Submitted To:
*Ohio Department
of Transportation*

Final Alternative Technical Concepts (ATC) Submittal
BEL-70-9.35 Interchange Improvement
Design-Build
Belmont County, Ohio
PID 120547

Figure 1 - Specified (Type 6) versus proposed (Type 2-A) curb configuration.

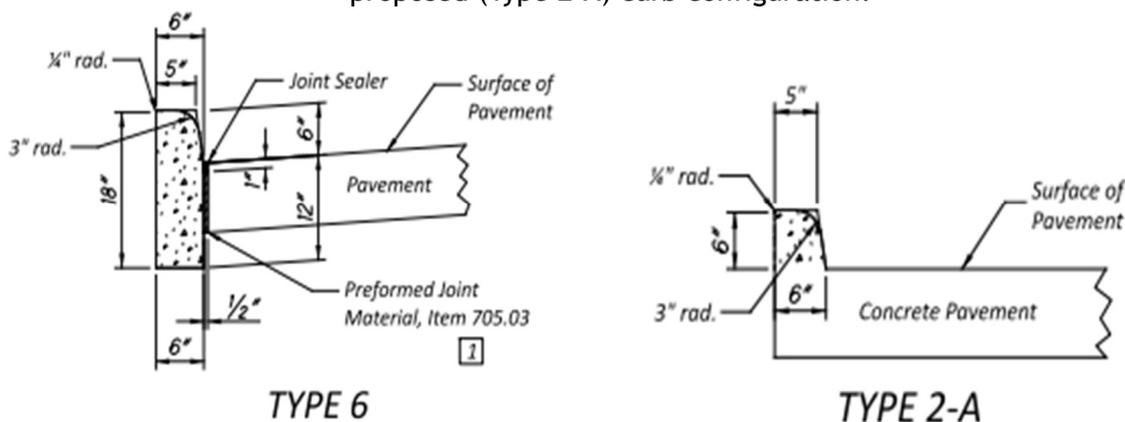
The DBT proposes changing the curb to Item 609E14000 - CURB, TYPE 2-A as shown in **Figure 1** below. This modification would improve production by allowing the curb to be paved with the pavement and eliminate the need for a separate activity with joints. This approach streamlines construction and potentially lowers costs, while maintaining the functional need for the curb.

2. **Deviation:** Page 37 of 63 of BEL-70-9.35, PID 120547 SCOPE OF SERVICES (Addendum 1) states: "All proposed curbing shall be Item 609E26000 - CURB, TYPE 6." Page 39 of 63 of BEL-70-9.35, PID 120547 SCOPE OF SERVICES (Addendum 1) states: "Curbing along SR-149 shall be Item 609E26000 - CURB, TYPE 6."

The DBT proposes to modify the above SCOPE OF SERVICES language to: "All proposed curbing shall be Item 609E14000 - CURB, TYPE 2-A or Item 609E26000 - CURB, TYPE 6." "Curbing along SR-149 shall be Item 609E14000 - CURB, TYPE 2-A or Item 609E26000 - CURB, TYPE 6."

SITE PLAN
 BRIDGE NO. BEL-70-0963 L/R
 I.R. 70 OVER S,R, 149

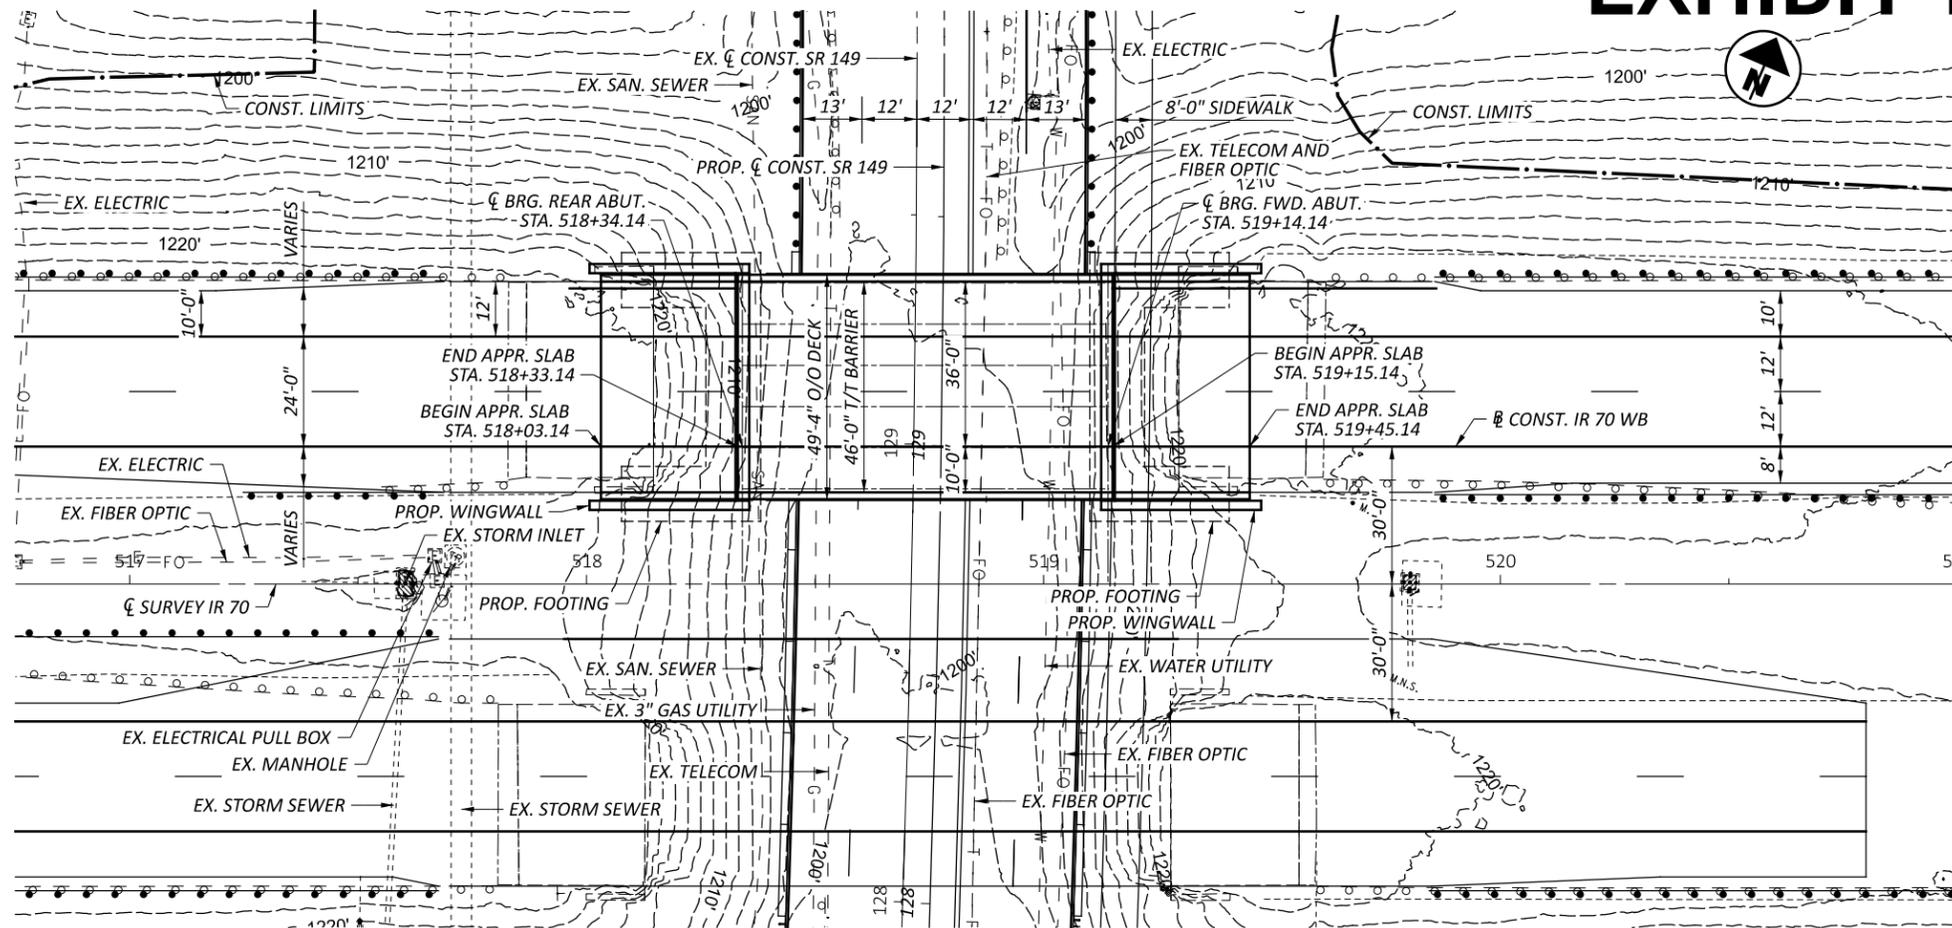
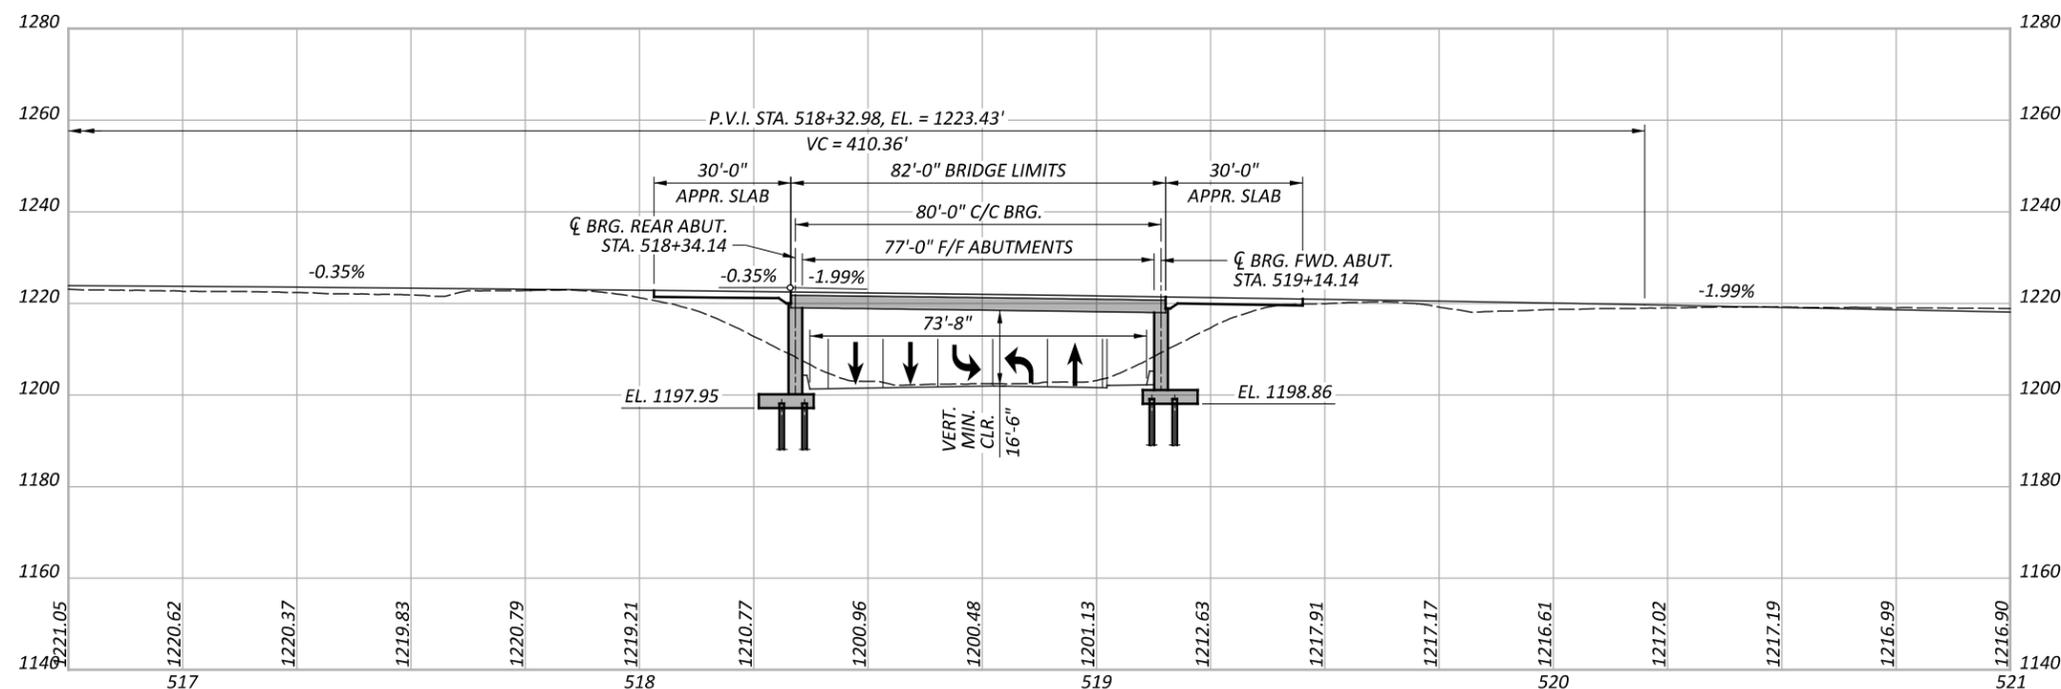
The DBT proposes revising these requirements to allow for alternative structure types, such as a single span bridge, to be considered. This modification will provide flexibility in the design process. This approach could also lead to more cost-effective, innovative, or constructible solutions while still maintaining the requirement for consistency between the eastbound and westbound bridge span arrangements. The proposed change ensures the final design will meet project objectives while allowing the DBT to explore optimized structural options. See Exhibit B for additional details.

2. **Deviation:** Page 43 of 63 of BEL-70-9.35, PID 120547 SCOPE OF SERVICES (Addendum 1) states: *"New bridges must be 3-span continuous composite steel beam structures with no skew. No other structure type will be allowed. The eastbound and westbound bridge span arrangements must match."*

The DBT proposes modifying this language to: *"New bridges may be designed as 3-span continuous or single span composite steel beam structures with no skew. The eastbound and westbound bridge span arrangements, span lengths, and bridge types must match."*

TYPE: SINGLE SPAN CONTINUOUS COMPOSITE STEEL GRADE 50 BEAMS
 WITH REINFORCED CONCRETE DECK ON SEMI-INTEGRAL
 ABUTMENTS

SPANS: 80'-0" C/C BEARINGS
 ROADWAY: 46'-0"
 LOADING: HL93 AND 0.06 KIPS PER SQ. FT. FUTURE WEARING SURFACE
 SKEW: NONE
 WEARING SURFACE: 1" MONOLITHIC CONCRETE
 APPROACH SLABS: 30'-0" LONG (AS-1-15, AS-2-15)
 ALIGNMENT: TANGENT
 CROWN: 0.016 FT/FT
 DECK AREA: 4,046 SF

SCHEMATIC PLAN BEGIN TO STA. 125+00

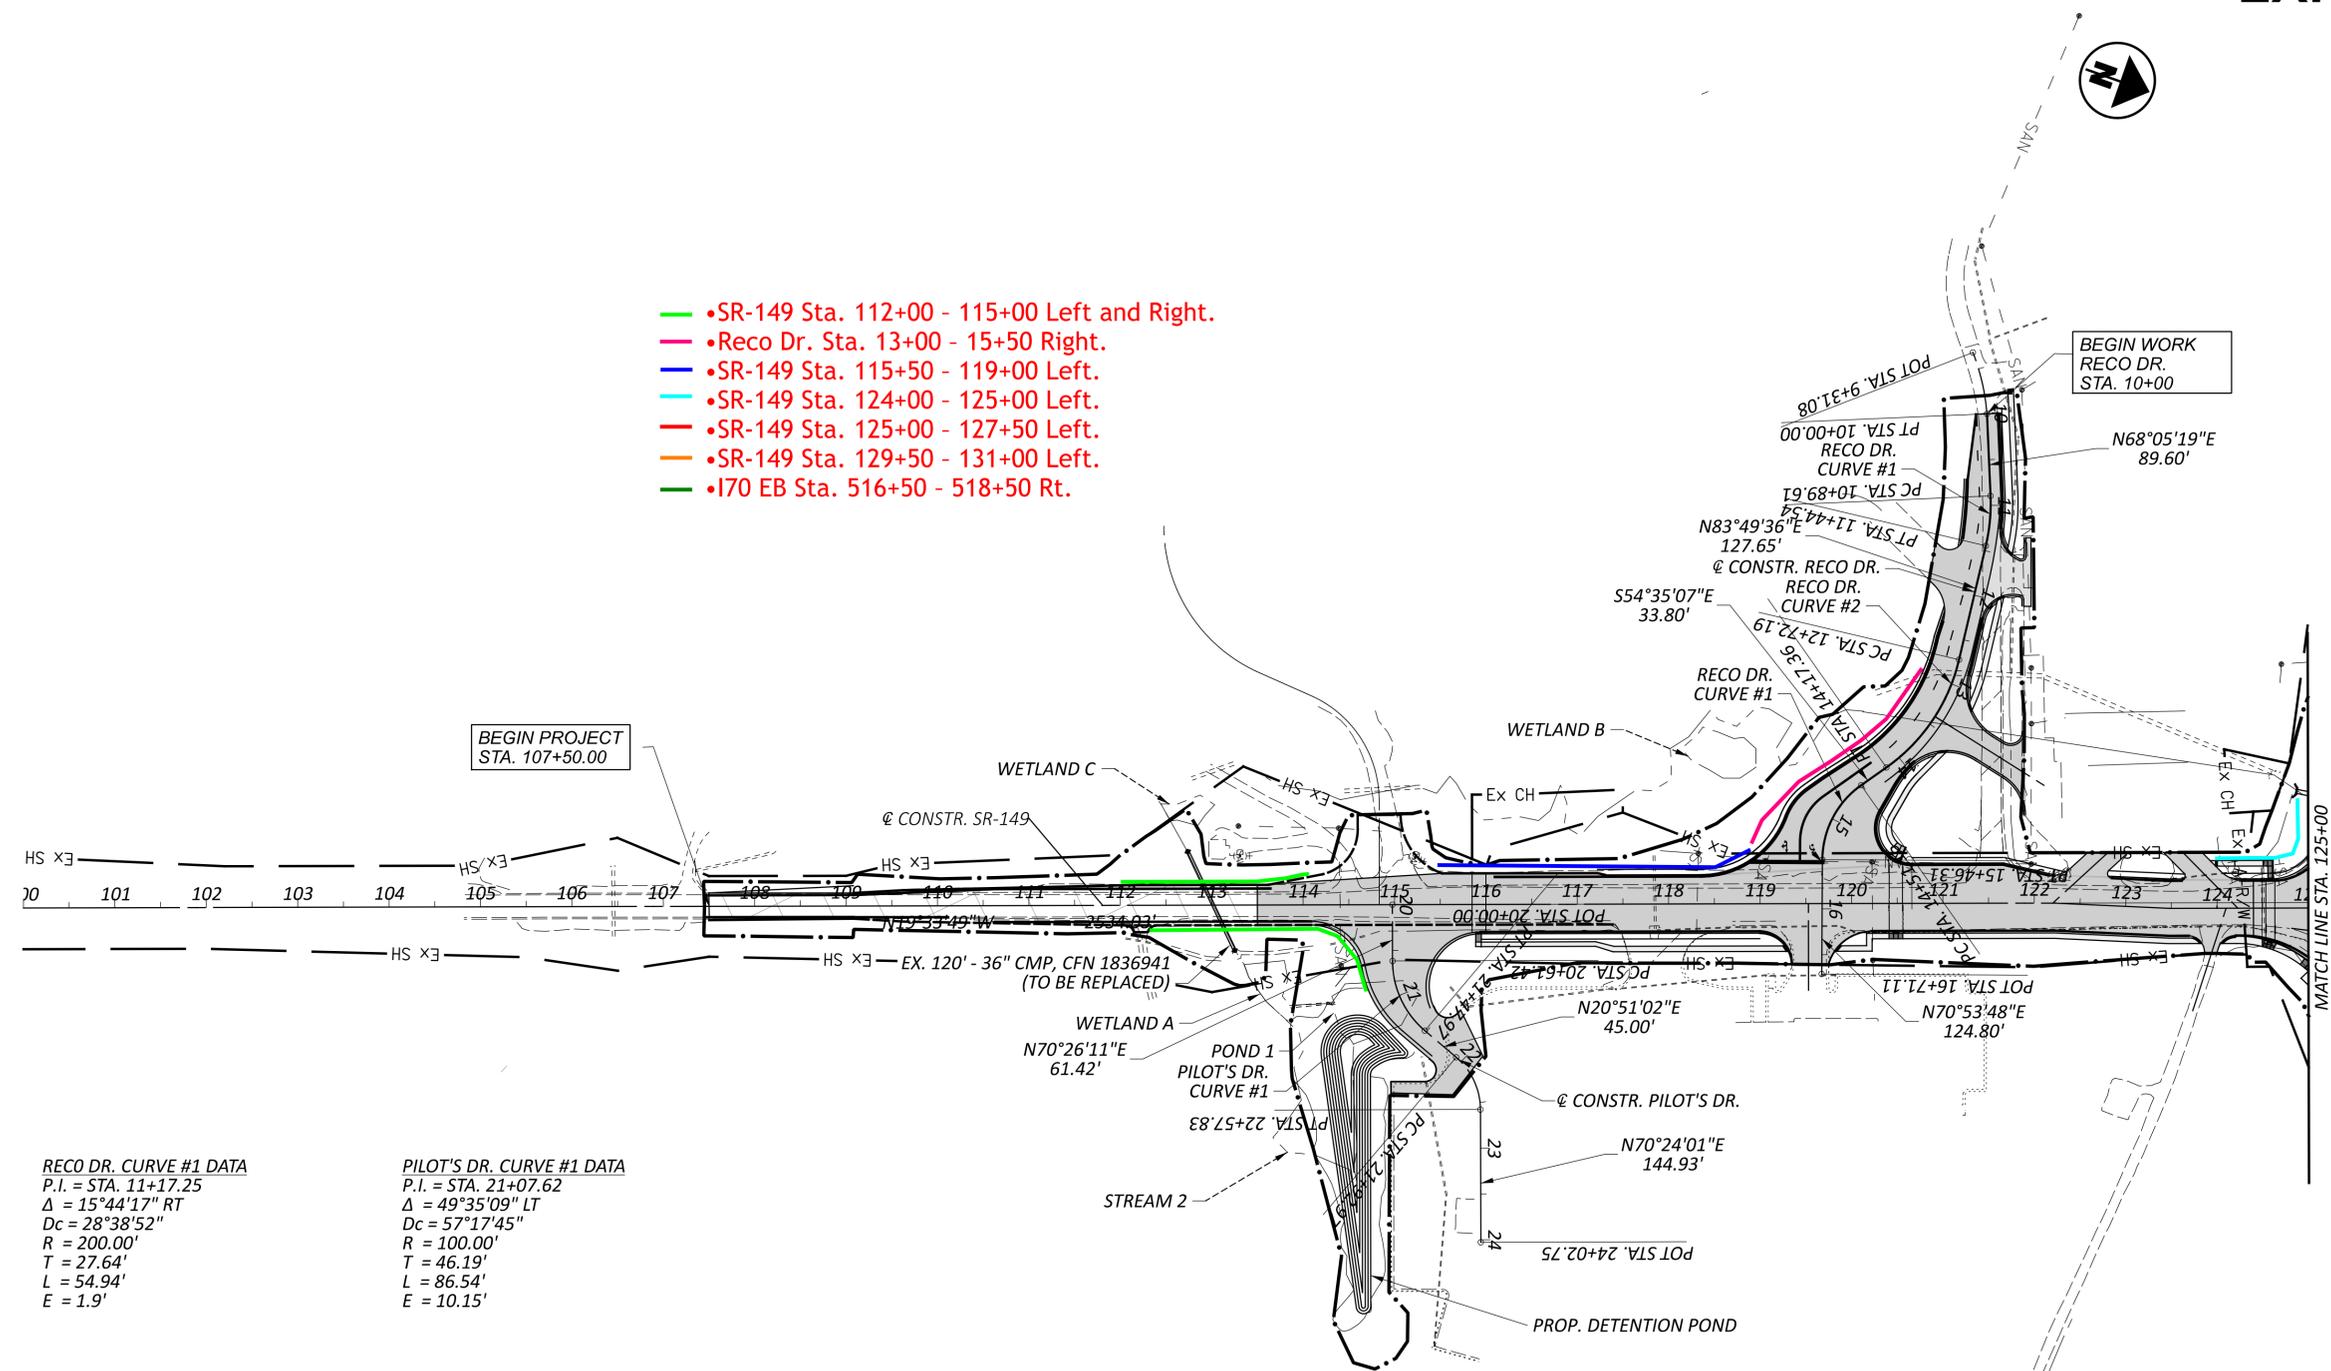
Our team may also implement combination 2H:1V on top of 1.5H:1V / 1H:1V slopes to minimize taller 1-1.5H:1V fills. See Exhibit F for additional details.

2. **Deviation:** Page 38 of 63 of BEL-70-9.35, PID 120547 SCOPE OF SERVICES (Addendum 1) states: "*The maximum side-slopes along SR-149, Reco Drive, and the ramps shall be 2:1. A 1.5:1 slope may be used only along IR-70 WB near the proposed approach slabs and bridge abutments.*"

- SR-149 Sta. 112+00 - 115+00 Left and Right.
- Reco Dr. Sta. 13+00 - 15+50 Right.
- SR-149 Sta. 115+50 - 119+00 Left.
- SR-149 Sta. 124+00 - 125+00 Left.
- SR-149 Sta. 125+00 - 127+50 Left.
- SR-149 Sta. 129+50 - 131+00 Left.
- I70 EB Sta. 516+50 - 518+50 Rt.

The DBT proposes to modify the above language to: "*The maximum side-slopes along SR-149, Reco Drive, and the ramps shall be 2:1. A 1:5 slope may be used along IR-70 near the proposed approach slabs and bridge abutments, and a 1.5:1 slope at the following locations:*"

- SR-149 Sta. 112+00 - 115+00 Left and Right
- Reco Dr. Sta. 13+00 - 15+50 Right
- SR-149 Sta. 115+50 - 119+00 Left
- SR-149 Sta. 124+00 - 125+00 Left
- SR-149 Sta. 125+00 - 127+50 Left
- SR-149 Sta. 129+50 - 131+00 Left.
- I70 EB Sta. 516+50 - 518+50 Rt.

1.5:1 may be steepened to 1:1 in locations above to minimize the impacts to existing culverts, drainage, wetlands, or utilities. All side slopes must comply with ODOT SS863 and Geotechnical Design Manual 502.2 requirements."
